MANDATORY SERVICE BULLETIN

NO. MSB-42-038/2

Installation of a modified water tube bracket.

„REDESIGN WATER TUBE BRACKET “

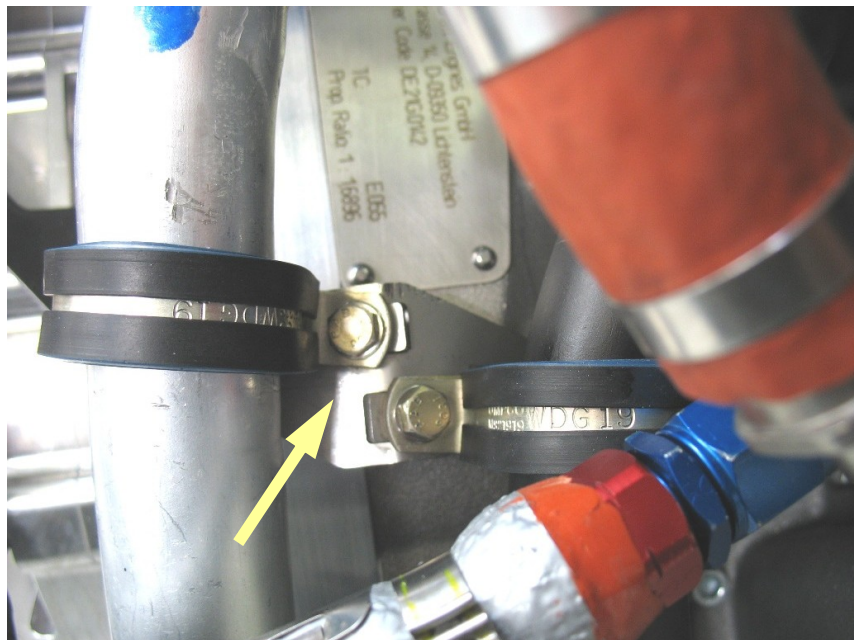
Remove screw from gear box, water tube mounting bracket (Part No. D60-7526-00-01) and oil line.

Remove screw on TAE- Engine block.

- 4 Install redesigned Mounting Plate Assembly D60-7526-99-00, pipe clamps and screws (Part Nr. MS21919WDG19 and LN9037-05014).
Torque screw on gear box with 20 Nm and secure it with Loctite 243.

| 6 | <p>Install screw on engine block, torque screw with 14 Nm and secure screw with Loctite 262. Install oil line.</p>  |
